Title: ERID-111328 SUBMITTAL OF THE RESPONSE TO THE NOTICE OF DISAPPROVAL FOR THE INVESTIGATION WORK PLAN FOR LOWER PAJARITO CANYON AGGREGATE AREA AND REVISION 1, INCLUDING 2 CD'S, EP2010-0521, EP2010-0522, LA-UR-10-7635

To:(Addressees - Organization) JAMES BEARZI, NMED

From:(Senders - Organization) MICHAEL J GRAHAM, LANL
 GEORGE J RAE, DOE

Figure 4.8-3 Organic chemicals detected at SWMU 18-003(d)

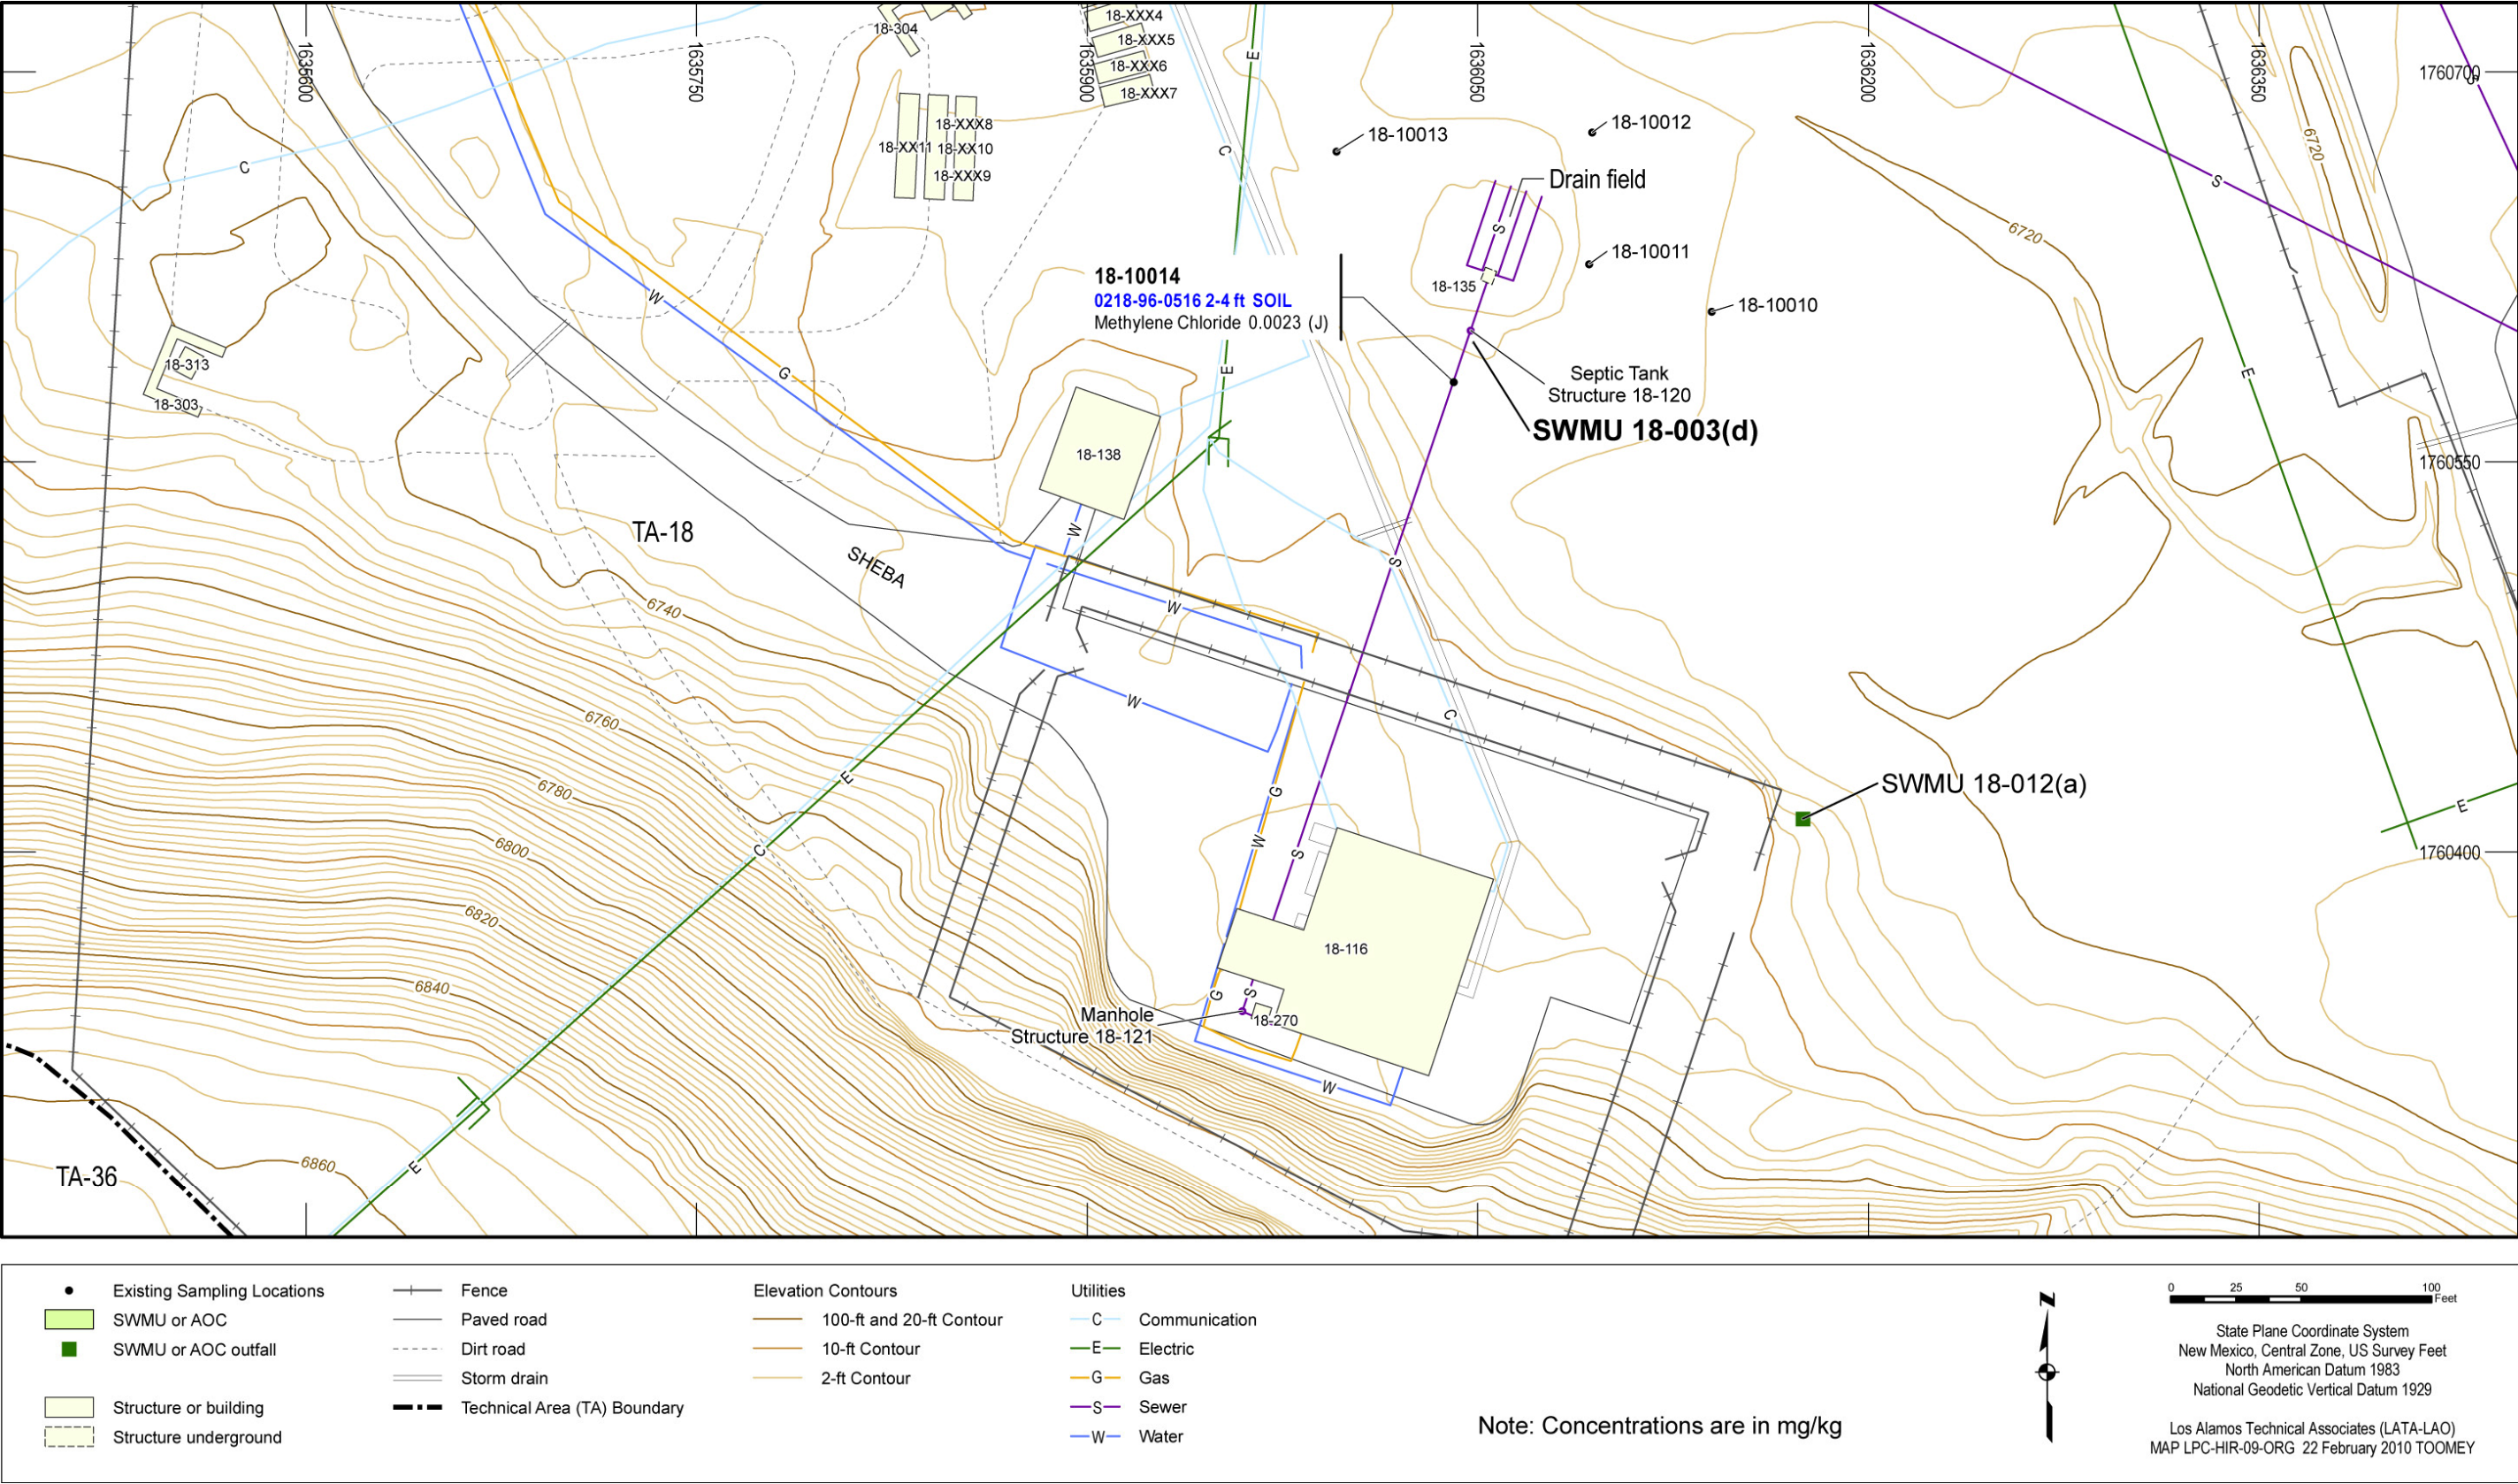
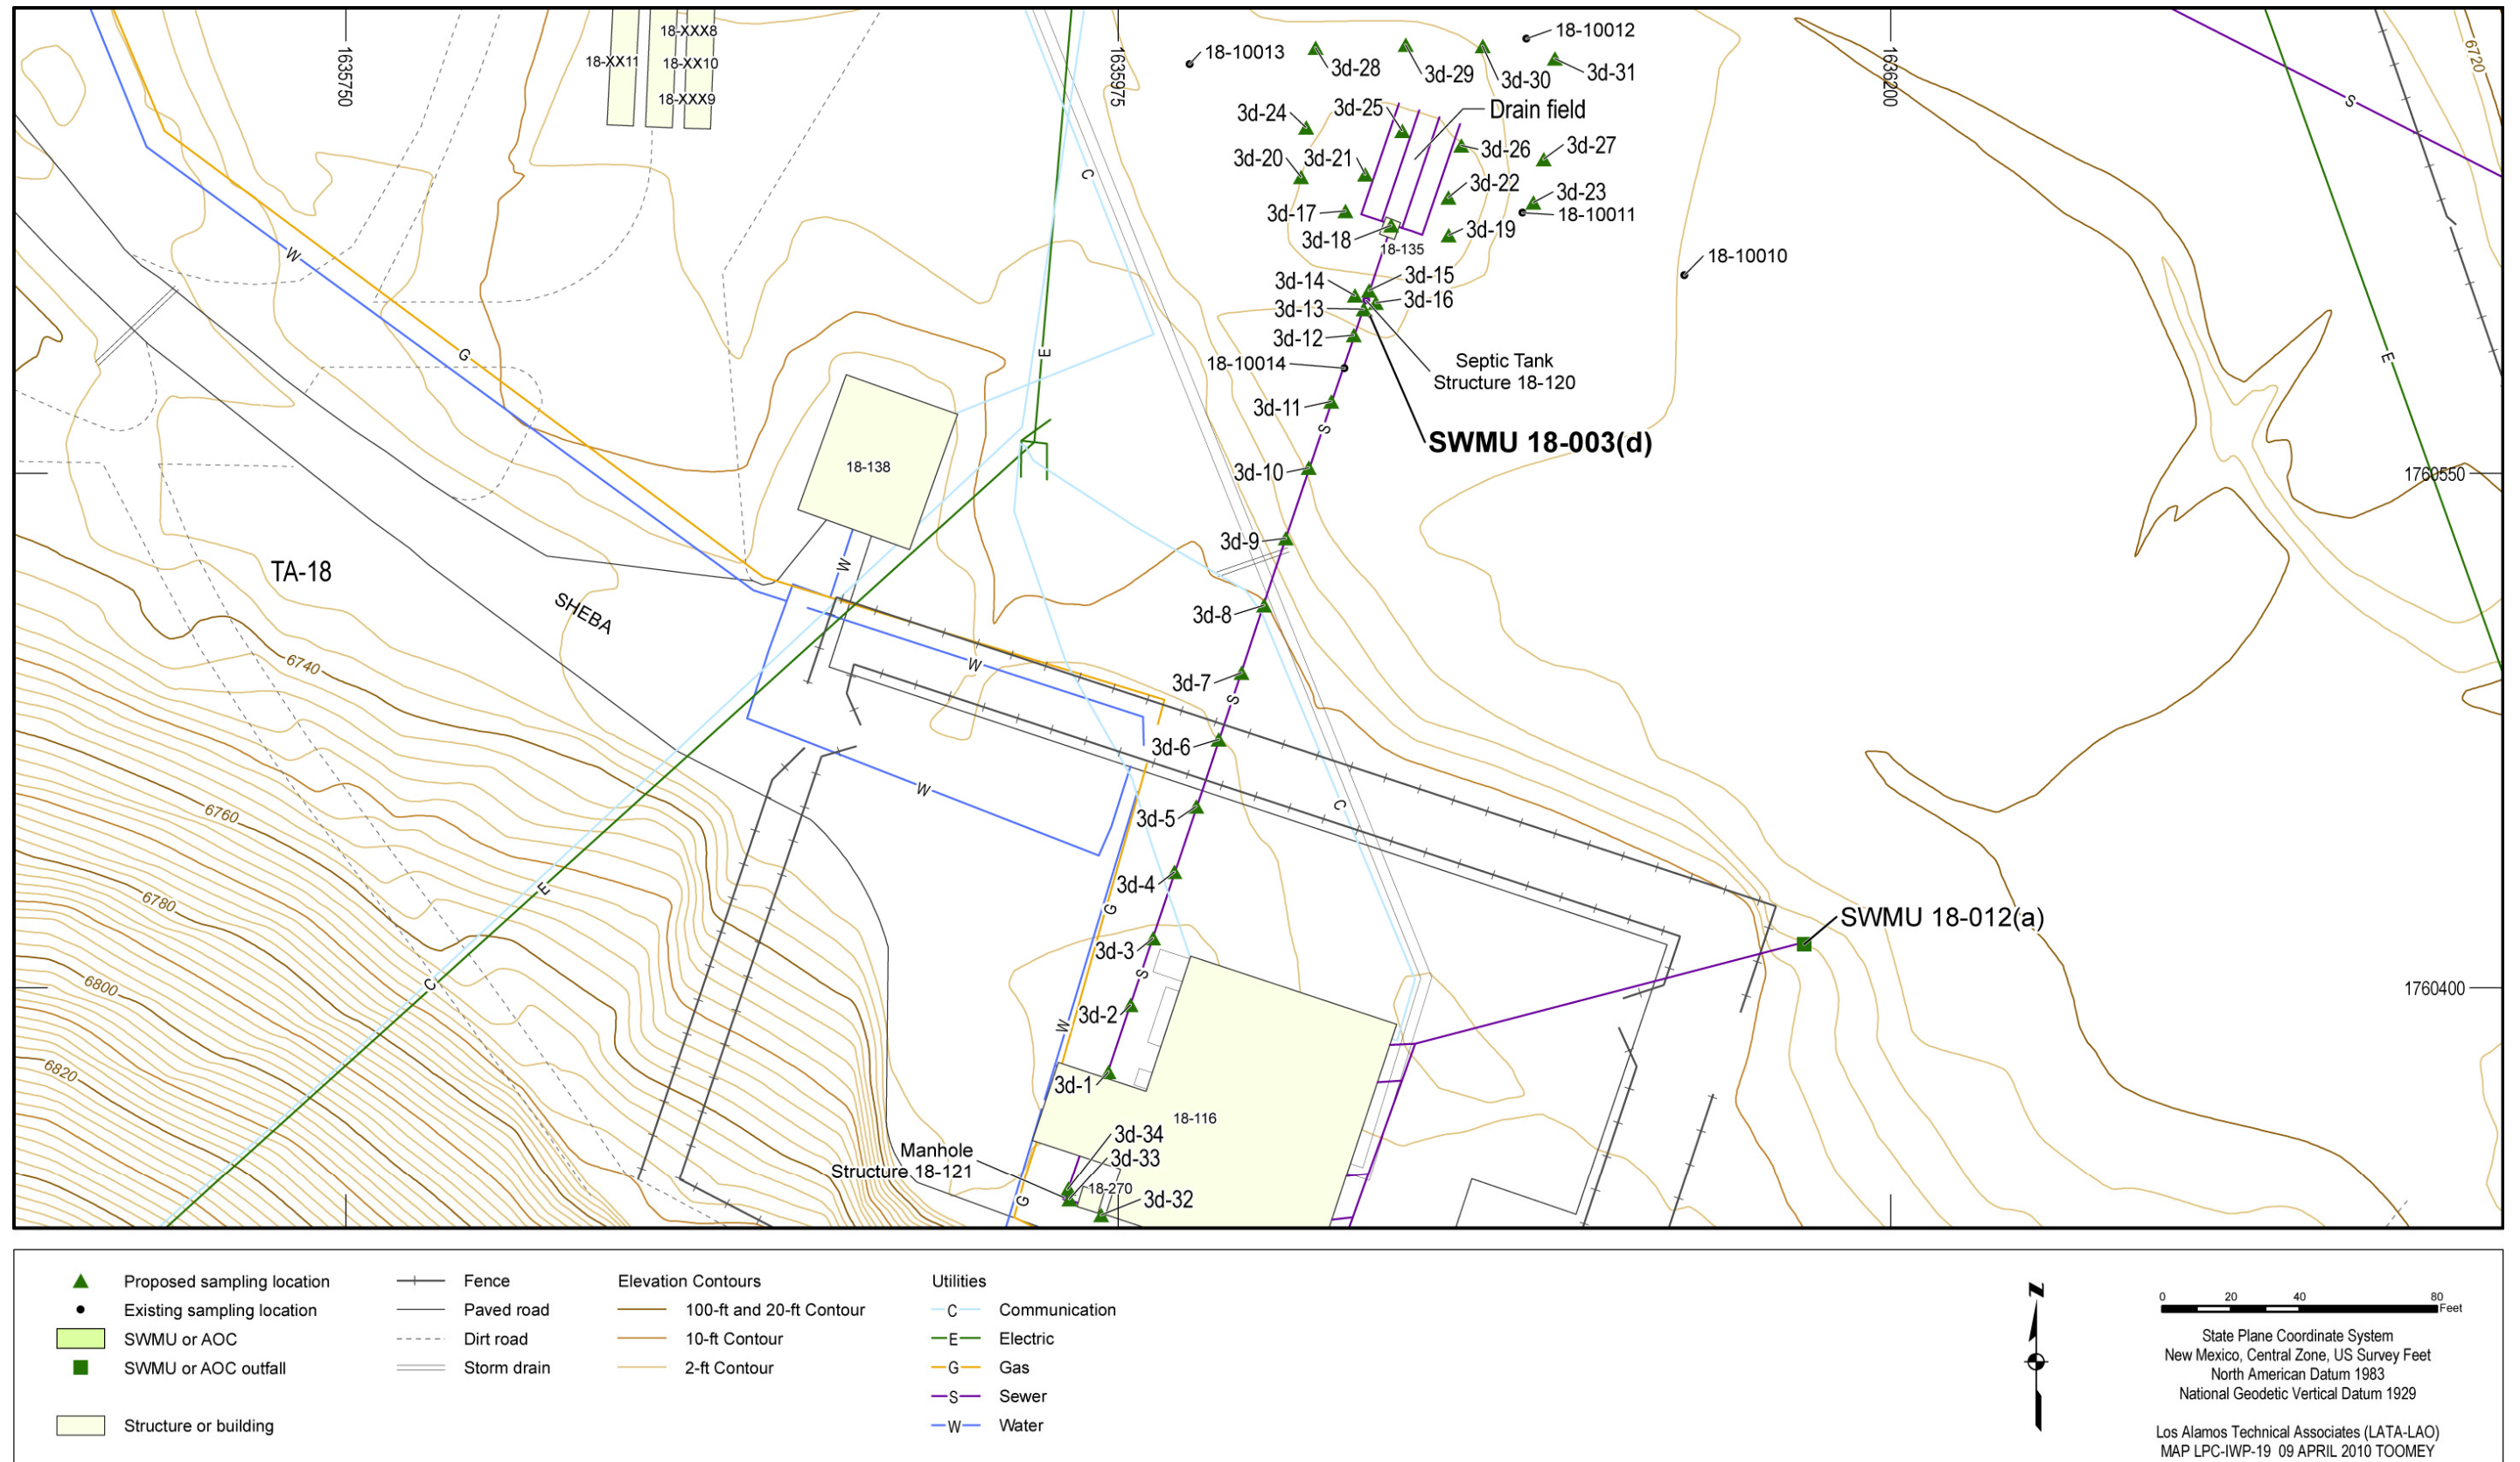
Plan Plate 1 shows several monitoring wells in the vicinity of this SWMU. If any monitoring wells are located within the site boundaries shown on Figures 4.8-1 through 4.8-4, the well(s) must be added to the figures. In the event one or more wells are added to the figures and, if the well(s) will be sampled in 2011, the monitoring results must be included in the IR.

NMED Comment: *The wells must be shown on Figures 4.8-1 through 4.8-4. If the well(s) will be sampled in 2011, the monitoring results must be included in the IR.*

12. Soil samples were collected from the monitoring wells when the wells were installed during the 1996–1998 VCA. Results from those samples are presented in section 4.8.2. The wells were subsequently abandoned and are no longer in use. The locations shown on Plate 1 are the existing sampling locations associated with the abandoned wells. The nearest active monitoring wells shown on Plate 1 are approximately 900 ft away from SWMU 18-003(d) and are not included in the site figures. The text in section 4.8.1 has been revised to clarify that the wells were abandoned and are no longer active monitoring wells.
